RE: Response to Review of PAP Amendment, Elk Canyon
Storage Upgrade - Utah Power & Light Company (UP&L),
Deer Creek Mine, ACT/015/018-88B, Folder #2,
Emery County, Utah

Re: Review of PAP Amendment, Elk Canyon Storage Upgrade Utah Power and Light Company (UP&L), Deer Creek Mine, ACT/015/018-88B, Folder #2, Emery County, Utah

ENGINEERING REPORT (DEFICIENCIES)

ELK CANYON STORAGE PAD UPGRADE

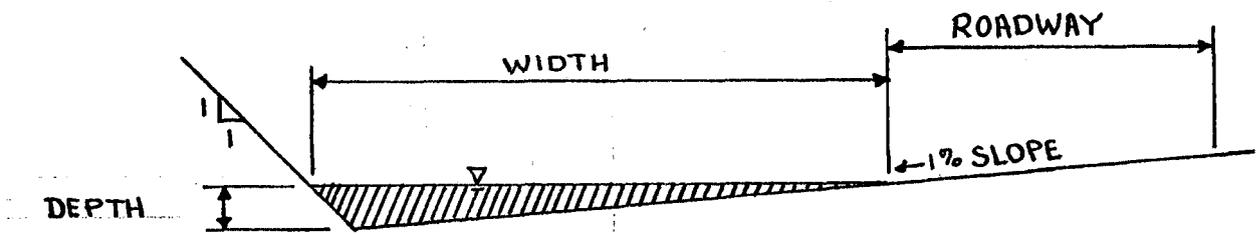
The operator does not address drainage along the road leading to the Tipple area. It is appropriate that the operator describe what kind of flows that may be expected from the 10-year, 24-hour storm event, and size a ditch that would convey drainage along the road to the Tipple area. The operator will also need to provide riprap protection for this ditch if erosive velocities are expected.

Drawing CM-10774DR 1 of 2 lacks sufficient detail to confirm that disturbed area drainage will be properly handled. A curb or berm should be shown along the south end of the storage area (pad) and the road should be insloped with an inside ditch (west) to prevent disturbed area drainage from flowing down fill slopes into the undisturbed inlets.

The ditch that will convey this runoff will be incorporated into the road itself as shown in the following diagram.

FLOW RATE = 0.516 CFS

<u>DITCH SLOPE</u>	<u>DEPTH</u>	<u>WIDTH</u>	<u>VELOCITY</u>
3%	.086'	8.71'	1.38
10%	.069'	6.95'	2.15

Because of the low velocity of the runoff in the ditch, no special lining material is necessary to prevent erosion of the base material.
